RULES FOR THE CONSTRUCTION AND CLASSIFICATION OF HIGH-SPEED CRAFT 2008

AMENDMENT No.1

November 2011

Fig. C6.5.2

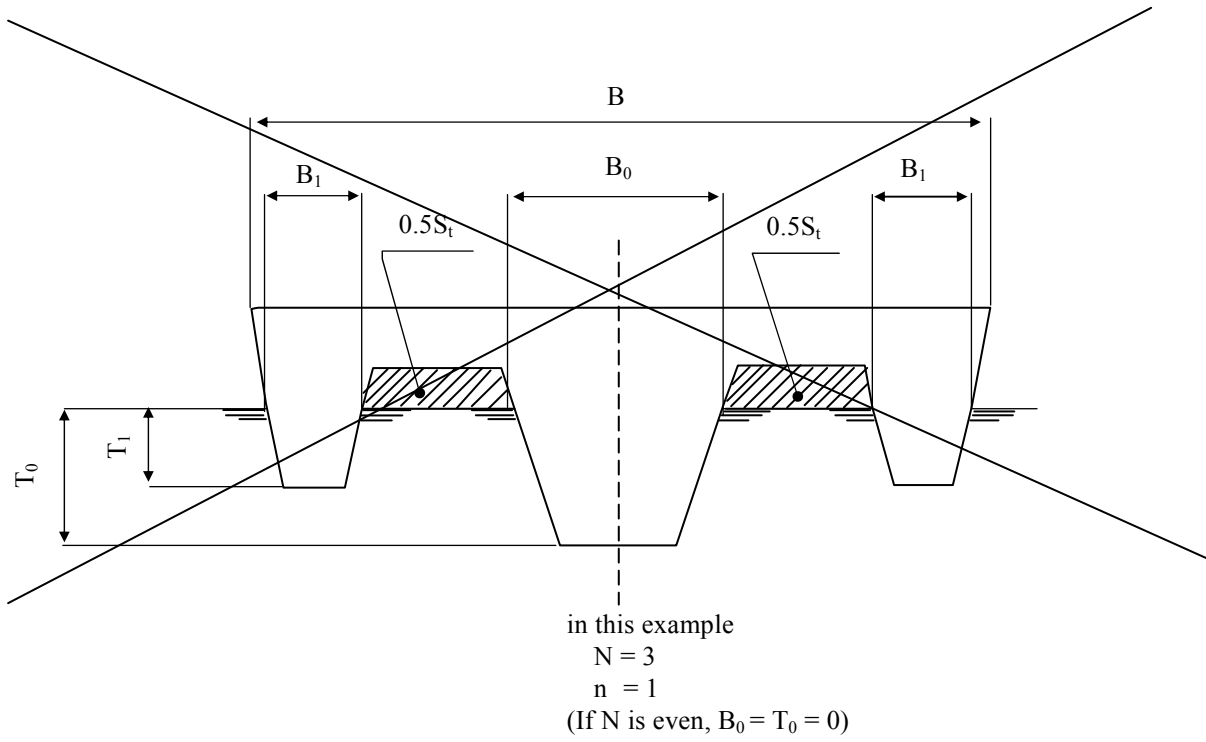
~~B_0, T_0 and B_i, T_i are, respectively, the breadth and the draught of the mid hull (if any) and of the lateral hulls, measured amidships, (see Fig. C6.5.2)~~

Fig. C6.5.2 has been deleted:
